**Slides supporting presentation to IPC 15 February
2023**

**Statement on 'Proposed Bowden's silver mine at
Lue'**

Barry N Noller

on behalf of the Lue Action Group

Figure 1 Size of dust particles for ingestion and inhalation.

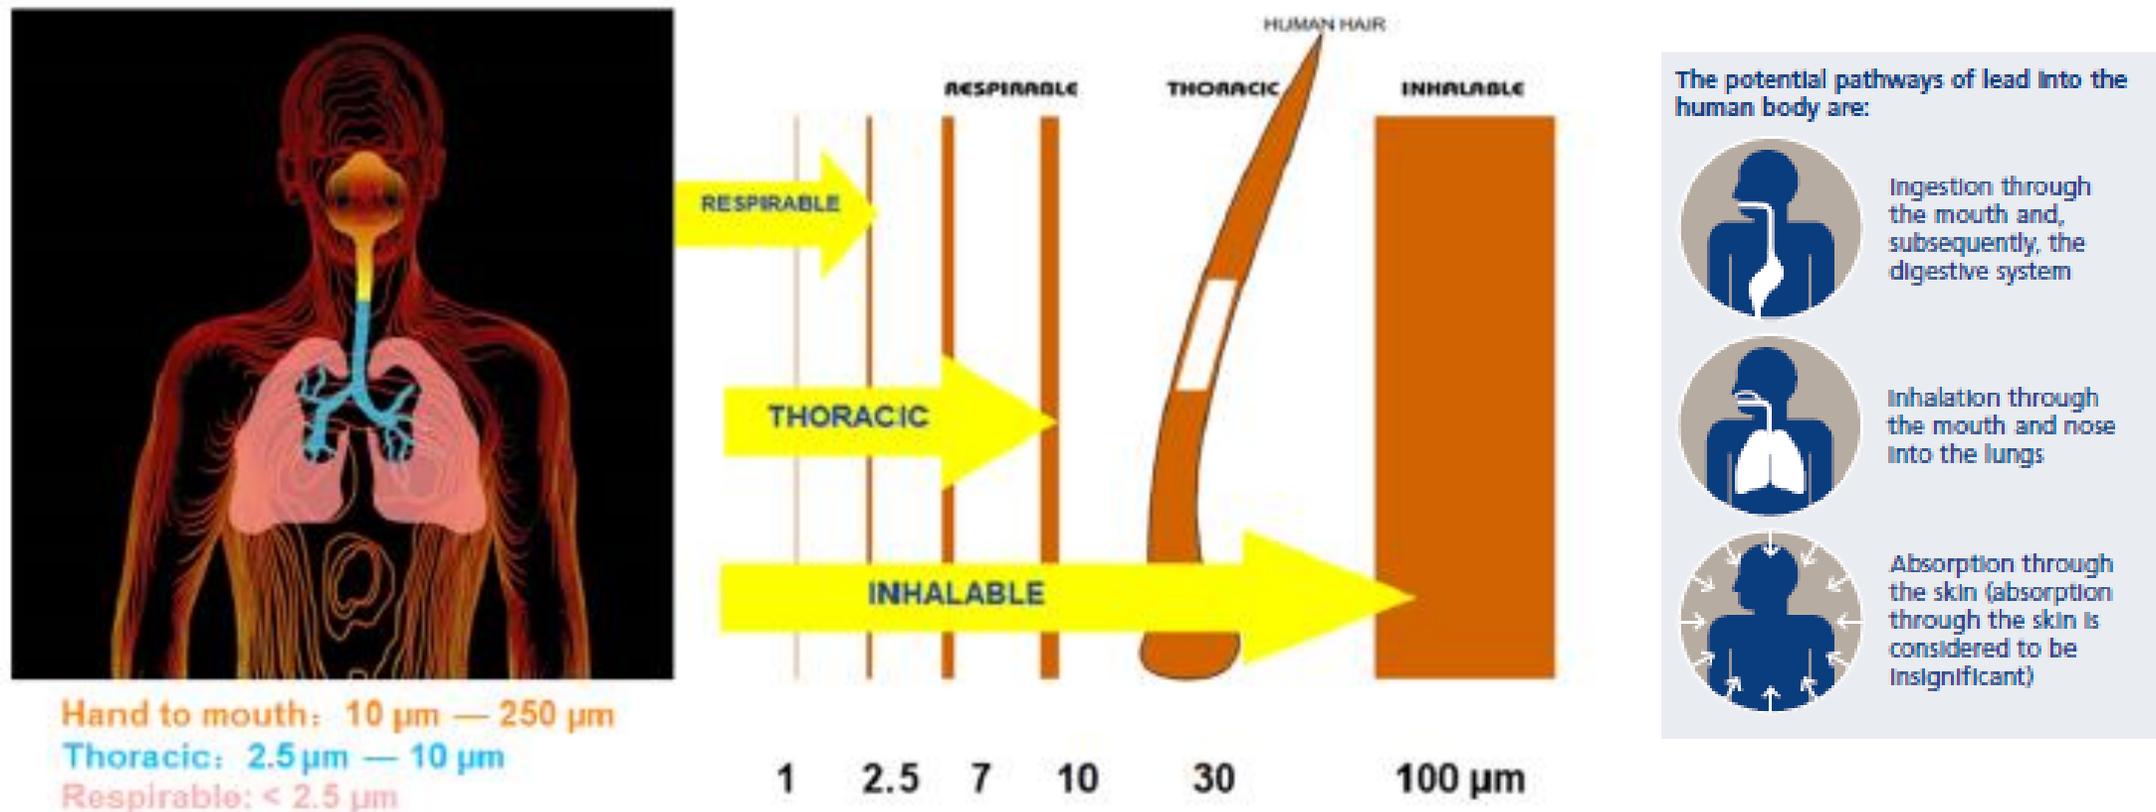
- Attention will be required with selecting dust monitoring methods to provide sufficient detail to enable management measures to be put in place to assess lead exposure at Lue.
- Figure 1 shows size of dust particles for ingestion and inhalation exposure.
- TSP in air used in modelling is measured to <50 μm diameter in NSW or 100 μm in QLD.
- Ingestion pathway up to <250 μm (Figure 1) is applicable for lead. Therefore TSP underestimates dust particle size in the fraction >50 μm to <250 μm for lead ingestion.
- Figure 2 shows examples of particle size distribution of mine dust from Mt Isa and shows the proportion of dust particles.

- It is appropriate to apply $3 \mu\text{g}/\text{m}^3$ in the PM2.5 fraction as the guideline to assess respirable crystalline silica exposure at Lue and follow international best practice.

See Figure 1 Size of dust particles for ingestion and inhalation.

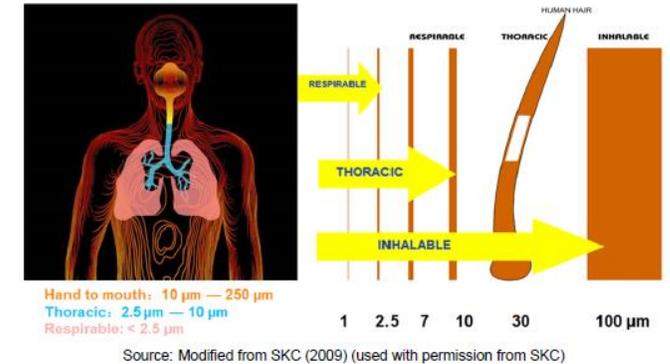
- During drier episodes such as the drought period 2017 – 2019 there is more potential to have dust generated for dry surface materials. Evidence for an accompanying reduction in stored water for dust suppression and dispersion of dry surface dust with non-availability of sufficient stored water for dust suppression may result in increased dust dispersion increasing lead. Evidence for this is given in Shireen Baguley's report for LAG.
